Technical Service Information

THM 3T40 (125C) NO CONVERTER CLUTCH APPLY

Figure 1

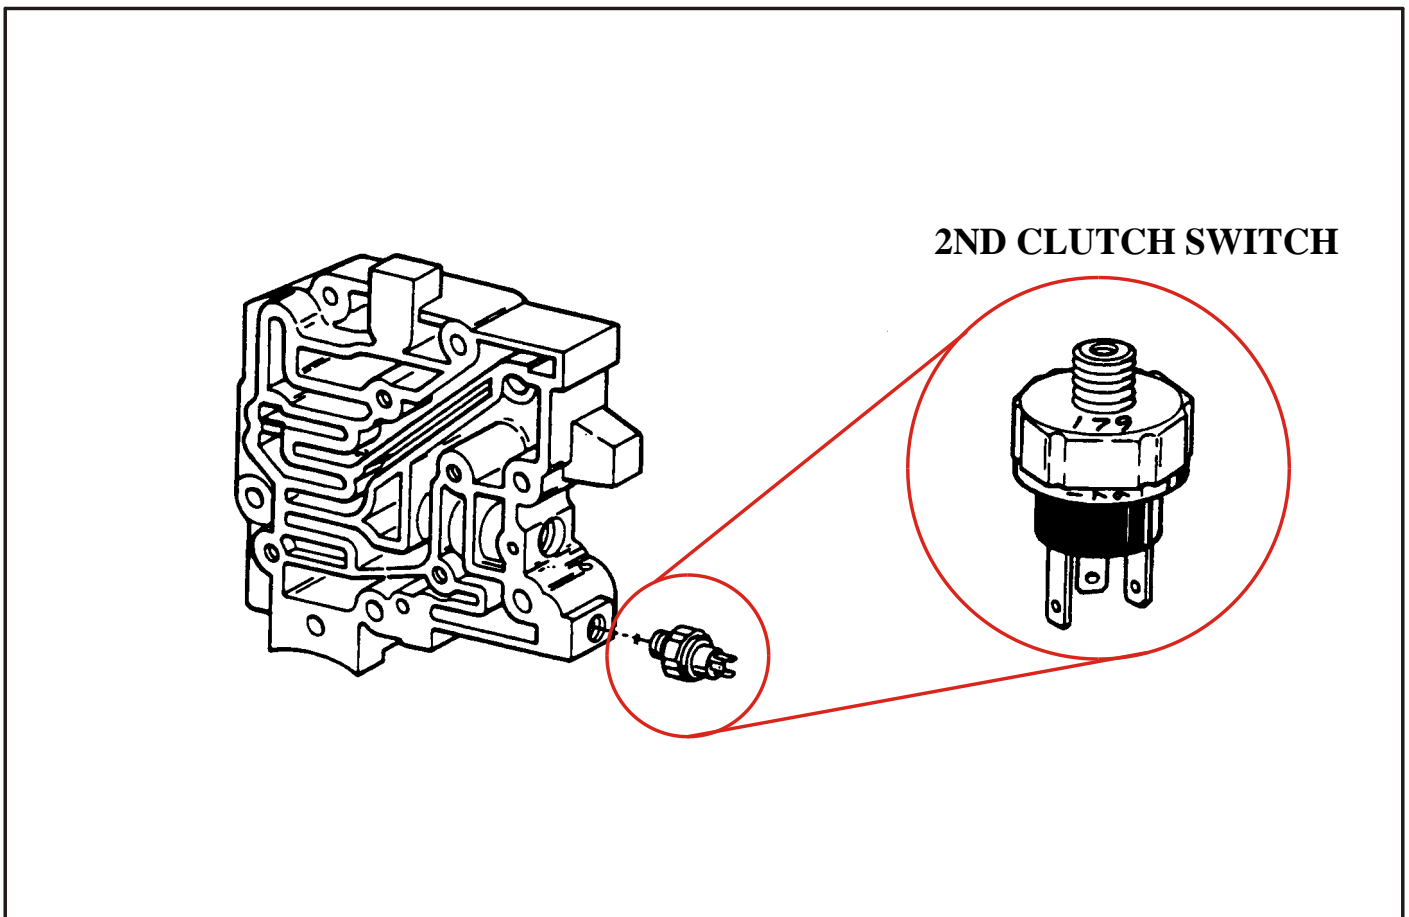
COMPLAINT: Torque converter clutch does not apply on 1988 or 1989 models only. The vehicle may also exhibit intermittent "Service Soon" light and/or trouble code 62 or 26 stored in the ECM.

CAUSE: The cause may be a defective 2nd clutch switch located on the auxillary valve body (See Figure 1). The 2nd gear switch has a 3 digit code stamped on the metal portion of the switch (See Figure 1). The first 2 digits in the code represent the week in which the switch manufactured, and the 3rd digit represents the year manufactured. All switches built with number 179 or lower, will not carry the amperage required to operate the converter clutch solenoid, and should be replaced. Terminals will appear black in color and may be loose in the switch.

CORRECTION: Replace the 2nd clutch switch with OEM Part Number 8664388. Inspect the converter clutch solenoid, 3rd gear switch, and entire wiring harness for excessive heat.
